KINGS BEACH STATE RECREATION AREA

GENERAL DEVELOPMENT PLAN

COMMENTS AND RESPONSES

Subject: PRELIMINARY GENERAL DEVELOPMENT PLAN AND RESOURCES MANAGEMENT PLAN,
KINGS BEACH STATE RECREATION AREA, SCH # 80070703

DESIGNED		DATE		REVISIONS		APPROVED		DATE		DRAWING NO.		SHEET NO.	
CHECKED						DEPARTMENT OF PARKS AND RECREATION		RESOURCES AGENCY OF CALIFORNIA		KINGS BEACH STATE RECREATION AREA		GENERAL DEVELOPMENT PLAN

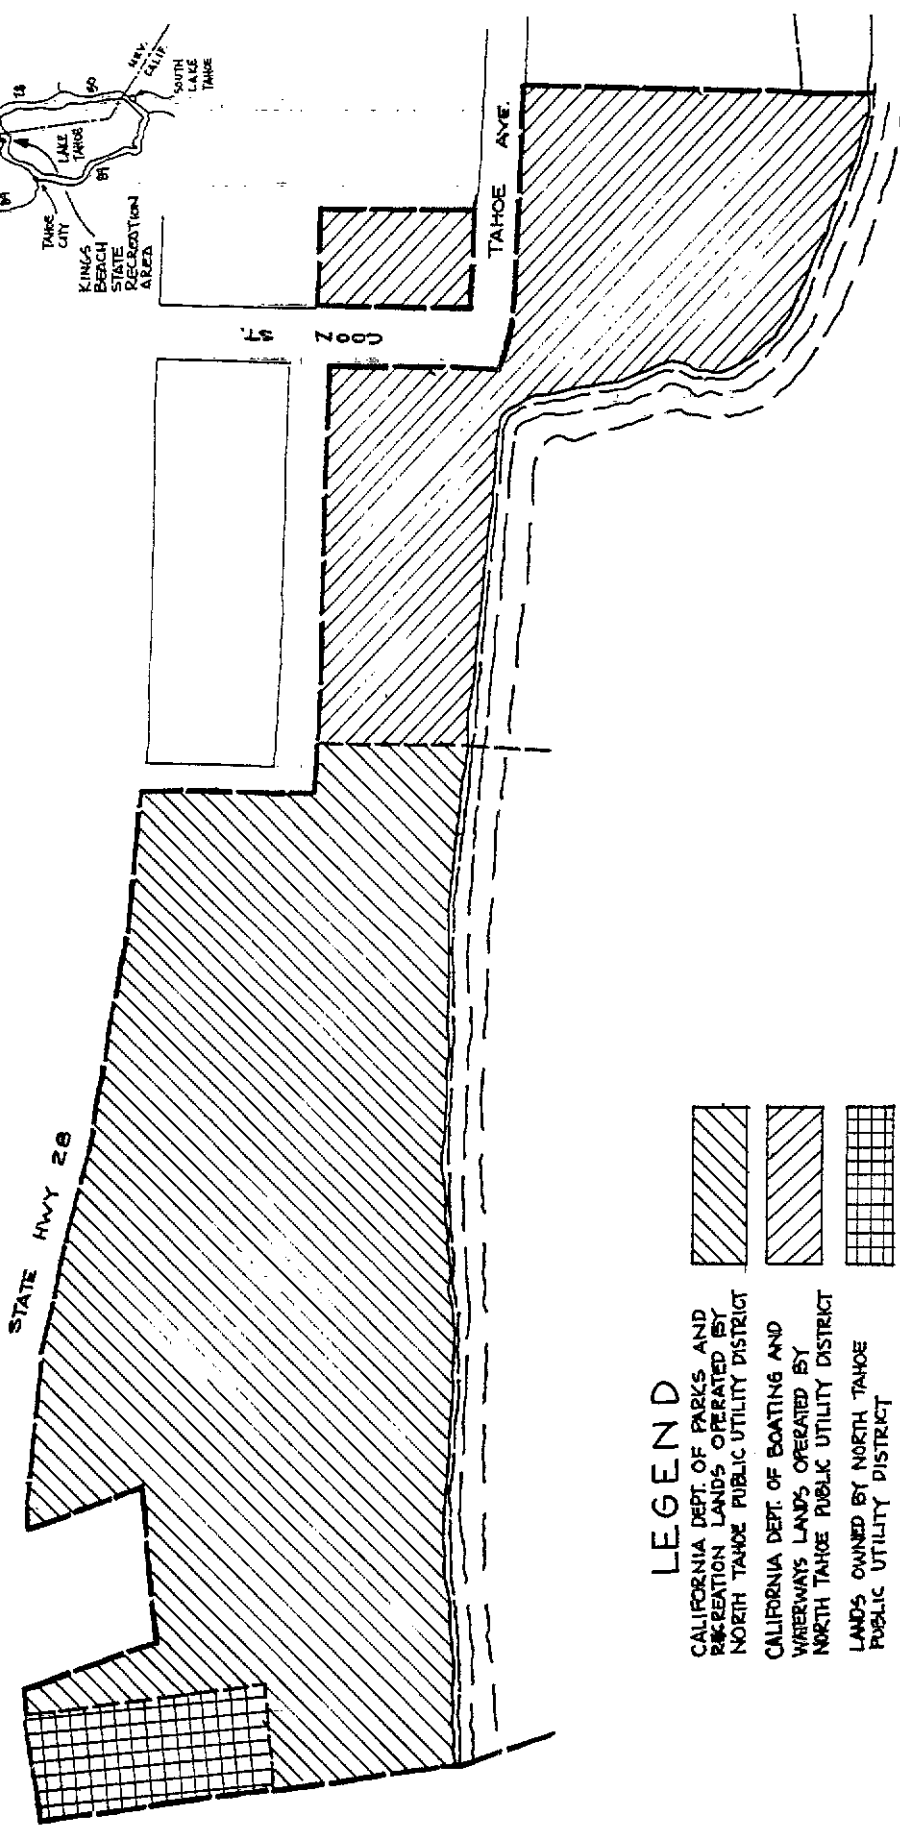
We suggest that the east driveway be located just east of the existing crosswalk opposite the intersection of Bear Street and Brook Avenue. This would provide a more standard approach to the highway and facilitate signalization if it becomes necessary in the future.

Bicycle parking is shown on the map, but there is no mention of type and quantity of bicycle facilities in the text of the plan.

1. On the redrafted plan for Kings Beach State Recreation Area we have incorporated your suggestion to relocate the entrance to a point opposite the intersection of Bear Street and Brook Avenue.
2. When the detailed construction plans are prepared for this unit an encroachment permit will be sought. An environmental assessment of the work proposed within your right-of-way will be enclosed with our application.

3. Locked bicycle parking (10 bicycles) will be provided. Construction details will be available for your review during the preparation of construction drawings.
